Recall Bulletin

SUBJECT: Front Safety Belt Anchor

MODELS: 2009-2014 Buick Enclave
2009-2014 Chevrolet Traverse
2009-2014 GMC Acadia
2009-2010 Saturn Outlook

This bulletin has been revised to update step 12 of the service procedure. A pull test must now be performed to ensure the connector and CPA are fully engaged. Please discard all copies of bulletin 14187C.

3916277

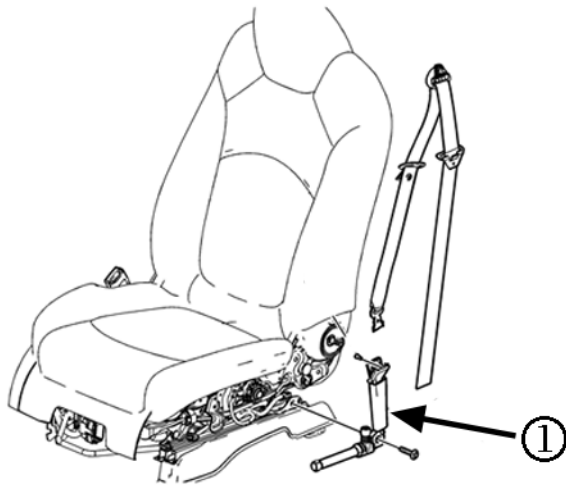
12. To ensure the connector and CPA are fully engaged, lightly pull on the connector after the CPA is seated. The CPA should not pull off the connector.
13. Reinstall the front seat belt anchor finish cover.
